**RE:** F.A.C Chapter 62-730 Permit Renewal Application for Triumvirate Environmental Services, Inc.  
Response to First Request for Information (RAI) from FDEP Letter Dated July 14, 2023  
EPA ID#: FLD980559728  
Current Permit #: 26916-009-HO

On July 14, 2023, Triumvirate received a First Request for Information (RAI) letter from FDEP. The following items were noted in the First RAI; Triumvirate's response follows each item:

# 80 Drum Unit

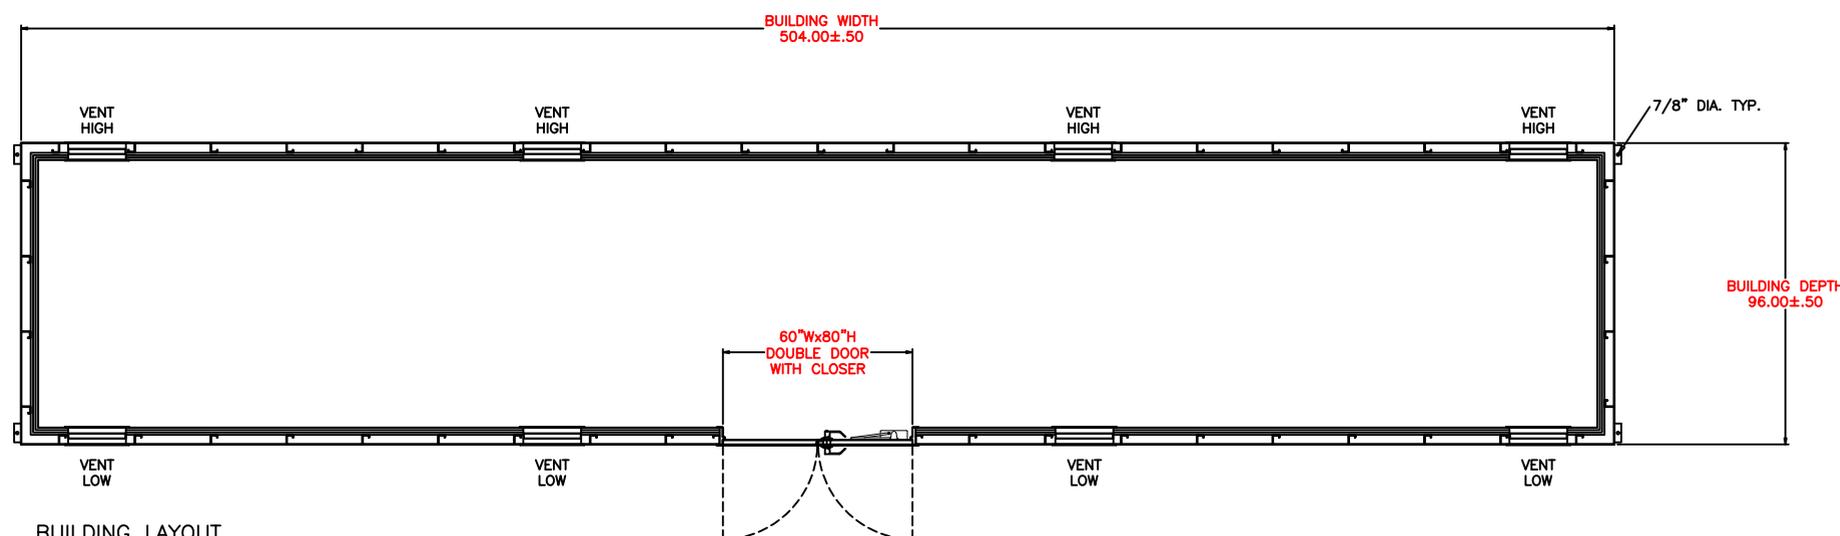
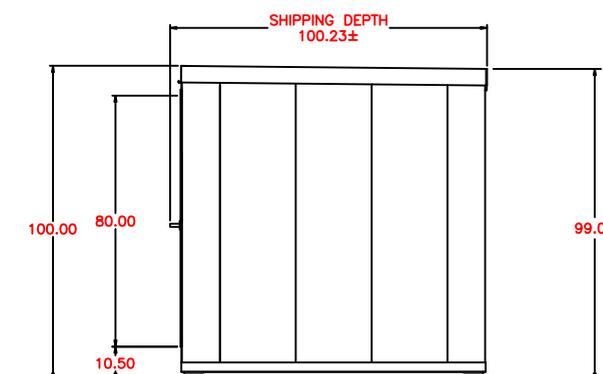
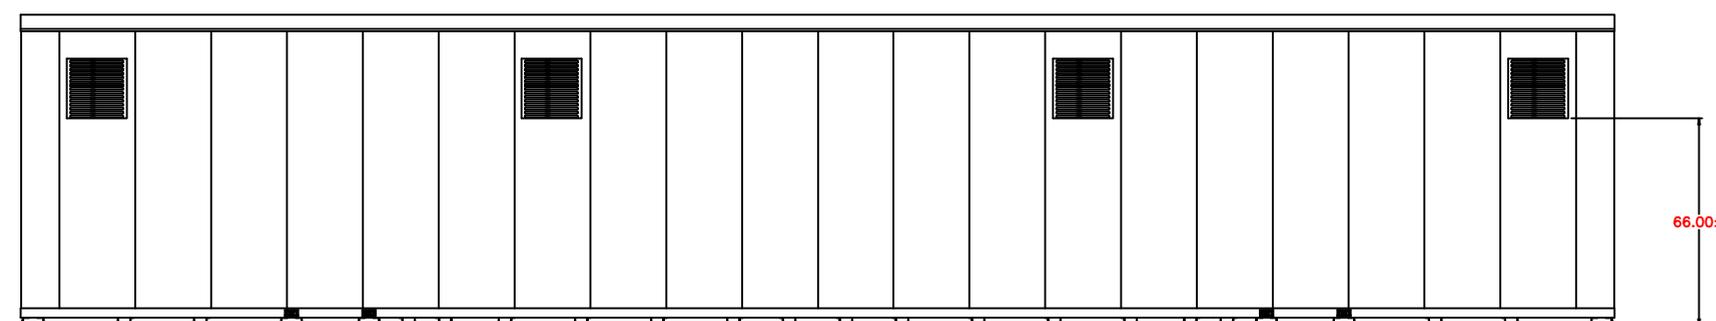
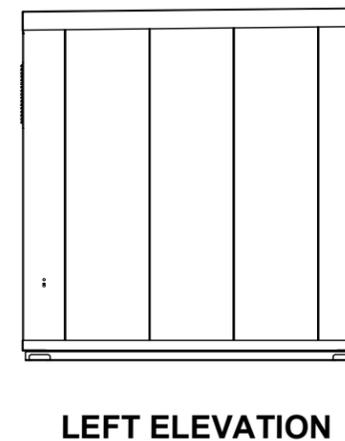
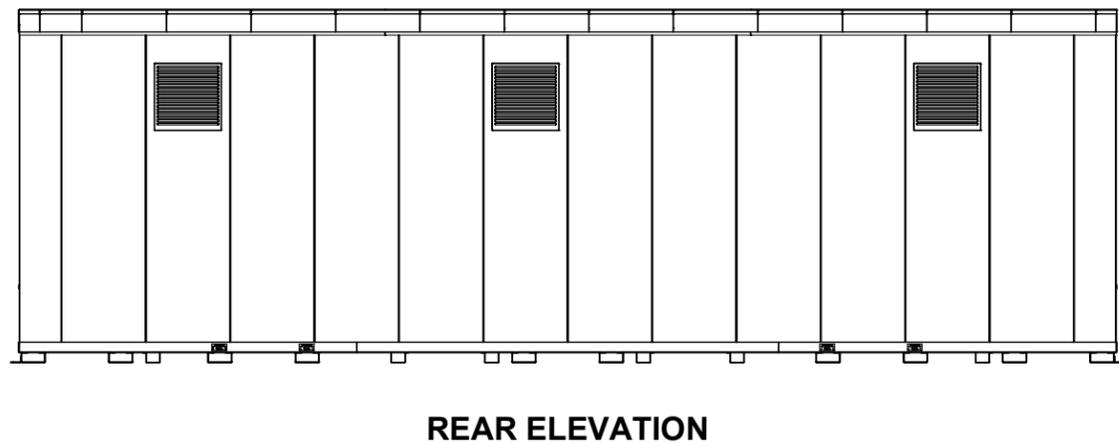
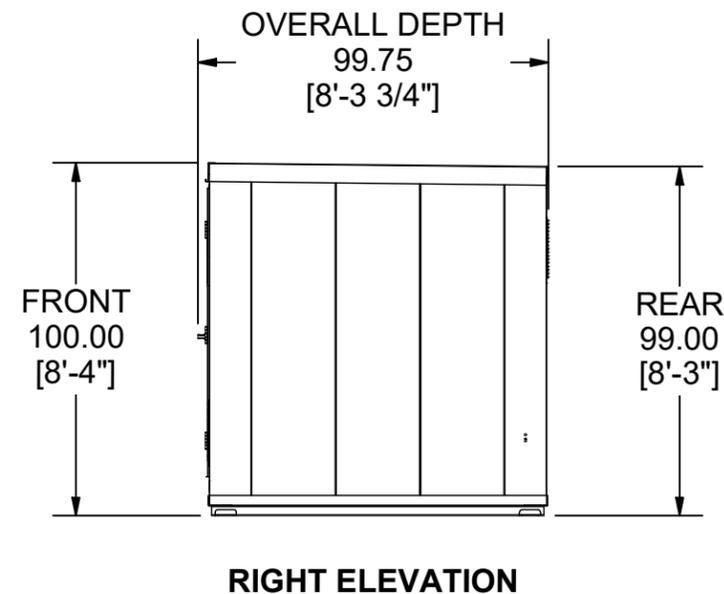
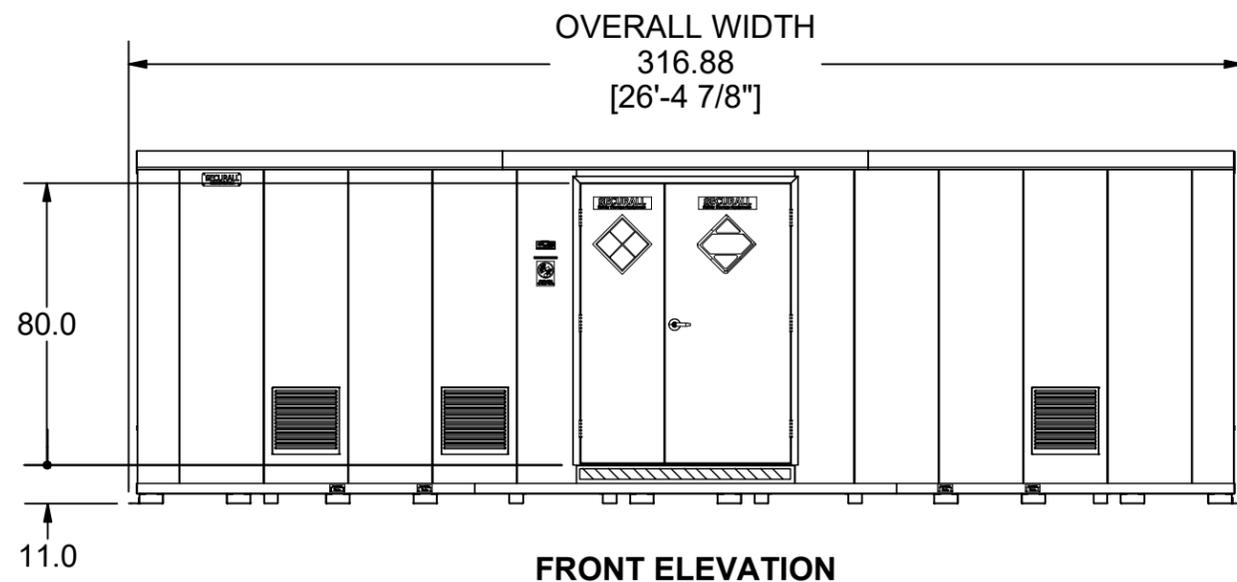
*[1/384] Cover Letter & Outline, #1: Prior to commencement of construction of the secondary containment, concrete, etc. for the flammable units, additional information will be needed. Triumvirate will submit to the Department design drawings, figures & calculations & specifics of the new construction.*

Finalized detail drawings and specifications of the flammable material storage units will not be available until a purchase order (PO) has been initiated with the flammable material storage unit vendor. Triumvirate requests the ability to hold PO issuance until FDEP approves the general concept and location of the flammable storage units. A drawing has been provided in [Attachment A](#) of this response letter to better demonstrate the size, location, and secondary containment plan for the flammable material storage unit area.

Preliminary specification sheets from the flammable material storage unit vendor have also been provided in [Attachment A](#) to show the preliminary design of each unit. The preliminary design documents have been reviewed by the Fire Department and they have given verbal approval that they agree with the flammable material storage unit plan; however, they are unwilling to put anything in writing ahead of the City building department's approval.

Total New Concrete Area Below Flammable Storage Units = 72 ft x 62 ft = 4,464 ft<sup>2</sup> (with a 2" curb around the perimeter)

Total Concrete Secondary Containment Area = 4,464 ft<sup>2</sup> x 2 inches = 744 ft<sup>3</sup> (5,565 gallons)

Each flammable storage unit has its own internal secondary containment sump:

- 42' x 8' Unit = 80 drum capacity (4,400 gal) with 1,243 gal secondary containment sump
- 26.5' x 8' Unit = 40 drum capacity (2,200 gal) with 757 gal secondary containment sump

A blind sump will be installed at the corner of the containment pad to allow for pumping of collected water. The pad will be sloped to the sump for proper drainage.

## Pallet Volume Calculation

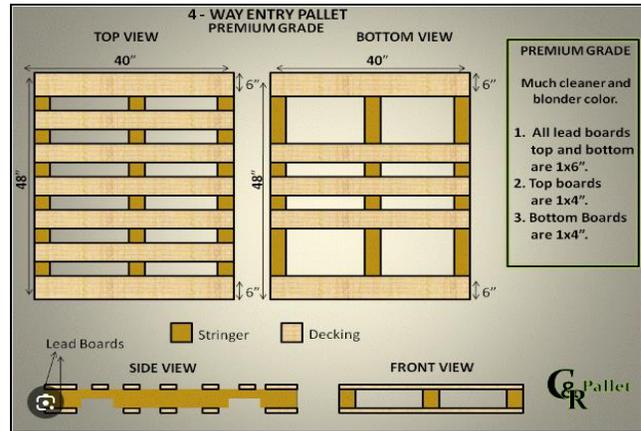
*[246/384 & 326-327/384]: Contingency Plan, Figure I.D.1, Existing Container Storage Layout; The figures show the three sections of the Northwest Subunit 101-105, East Subunit 201-210 & South Subunit 301-306 sections. Please explain the “volume displacement of 3 pallets: 3 X 5.40 gallon/pallet = 16.20 gallon”. How is that value derived? Actual testing?*

The value used for the volume displacement of a pallet was taken from historical values used in previous permit renewal applications. Current Triumvirate personnel have not been able to find the origin of this value; however, Triumvirate has recalculated the volume of containment that would be displaced by a standard wooden pallet and has verified the 5.4 gallon/pallet value. A summary of the calculations used for this determination are shown in [Attachment C](#) of this response letter.

A Standard size wooden pallet was used for the pallet volume calculation. Dimensions are 48" x 40". The spill over height of the secondary containment is 3.5". The top boards are higher than 3.5" from the ground; therefore, the top boards were not used in the volume calculation.

<b>Total Volume of Pallet (Lead + Span + Stringer)</b>	<b>5.4 gal</b>
--	----------------
